**ZONING AMENDMENT
& SUBDIVISION STAFF REPORT****Date: October 7, 2010****APPLICANT NAME**

Theodore Knights of Columbus Subdivision

LOCATION5800 Swedetown Road North
(North side of Swedetown Road North, 300'± West of U.
S. Highway 90 West)**CITY COUNCIL
DISTRICT**

SITE PLAN

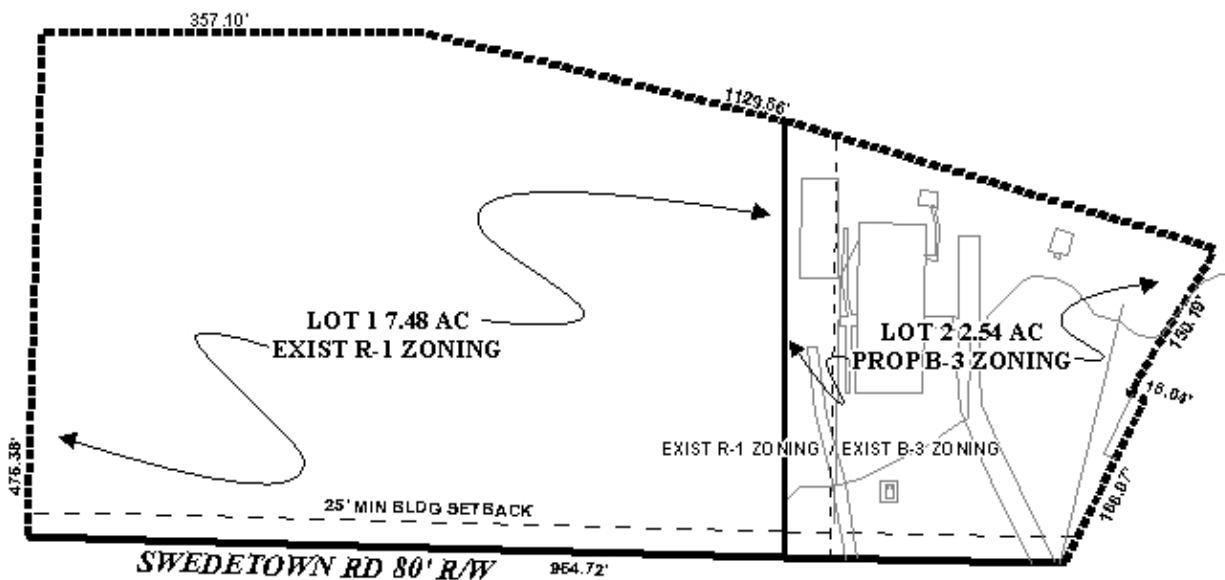
It has been the Commission's policy to require sites to be brought into compliance with the Zoning Ordinance as a condition of a rezoning. The site plan indicates that the site currently does not have any designated parking, and has two driveways, one 20-foot wide asphalt drive and one 10-foot wide asphalt and gravel drive. The westernmost driveway should be removed

and sodded, while the eastern driveway should be widened to city standard, and appropriate parking provided. As the site abuts residentially zoned property, construction of a buffer compliant with Section 64-4.D.1. of the Zoning Ordinance will be required wherever the site abuts residentially zoned or utilized property. Modifications necessary to bring the dumpster into compliance, including screening, setbacks, and required utility connections should be required. Additionally, full compliance with the tree planting and landscaping ordinance should be required.

- 1) removal and sodding of the westernmost driveway on the site;*
- 2) modification of the eastern driveway to meet city standards;*
- 3) provision of appropriate parking on the site;*
